UNITED STATES PATENT AND TRADEMARK OFFICE

APPLICATION NO.	FILING DATE	FIRST NAMED INVENTOR	ATTORNEY DOCKET NO.	CONFIRMATION NO.
10/723,644	11/26/2003	G. David Jang	S63.2H-11280-US01	8788
499 7590 06/25/2009 VIDAS, ARRETT & STEINKRAUS, P.A. SUITE 400, 6640 SHADY OAK ROAD EDEN PRAIRIE, MN 55344				
EXAMINER				
BUL VY Q				
ART UNIT		PAPER NUMBER		
3773				
MAIL DATE		DELIVERY MODE		
06/25/2009		PAPER

Office Action Summary

DETAILED ACTION

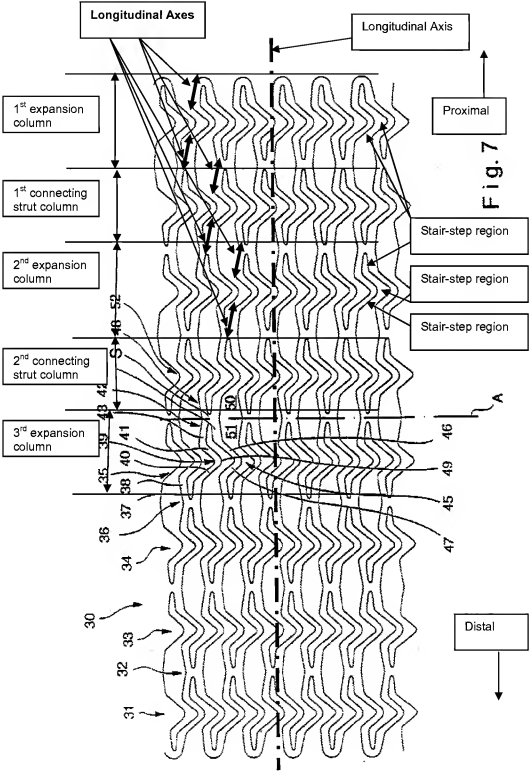
Claims 1-9, 10, 12-23 are rejected under 35 U.S.C. 102(e) as being anticipated by WO98/35634 or US 6,193,747 B1.

As to claims 1-9, 10, 12-23, Fig. 7 of WO98/35634 or US 6,193,747 B1 as shown below includes substantially all structural limitations, such as stair steps, 1st, 2nd, 3rd expansion columns, 1st and 2nd connecting strut column, of the claimed invention. Notice that at least one of one proximal section and at least one of one distal section of 1st connecting struts have longitudinal axes parallel with at least one longitudinal axis of a 1st expansion strut and at least one longitudinal axis of a 2nd expansion strut as shown on next page below:
